Access Compliance Report Public Rights-of-Way (Curb Ramps)

Main Street: N/A Cross Street: HAZARD_AVE Location: NE

ADA ID: RPRK220203122207 Ramp Type: Type 4 - Parallel Initial Pass/Fail: Fail Overall Compliance: No Severity Score: 15

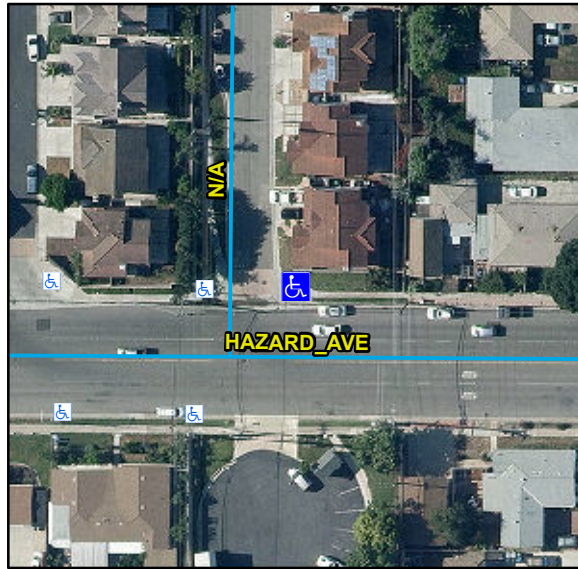
Compliance	Description	Data	Compliance	Description	Data
N/A	Ramp Length LT (in)	80	N/A	Ramp Length RT (in)	78
Yes	Ramp Width LT (in)	78	Yes	Ramp Width RT (in)	78
No	Ramp Run Slope LT (%)	9	Yes	Ramp Run Slope RT (%)	6
Yes	Ramp Cross Slope LT (%)	1	Yes	Ramp Cross Slope RT (%)	0.1
N/A	Landing Present	N/A	N/A	DWS Provided	N/A
N/A	Landing Length (in)	N/A	N/A	DWS Contrast	N/A
N/A	Landing Width (in)	N/A	N/A	DWS Length (in)	N/A
N/A	Landing Run Slope (%)	N/A	N/A	DWS Full Width	N/A
N/A	Landing Cross Slope (%)	N/A		DWS Offset Type	N/A
N/A	Landing Movement Obstructed?	N/A	N/A	DWS Offset Left (in)	N/A
	Landing Movement Type	N/A	N/A	DWS Offset Right (in)	N/A
N/A	Landing Shared	N/A			
N/A	Clear Space	Yes			
N/A	Clear Space To Crosswalk (in)	N/A			
N/A	Marked Crosswalk 1	No	N/A	Marked Crosswalk 2	No
	Crossing 1 Direction	W		Crossing 2 Direction	S
N/A	Marked Crosswalk 1 Width (in)	N/A		Marked Crosswalk 2 Width (in)	N/A
N/A	Ramp Inside Crosswalk 1	N/A	N/A	Ramp Inside Crosswalk 2	N/A

Remove & Replace Curb Ramp With Two New Directional Ramps or Equivalent.
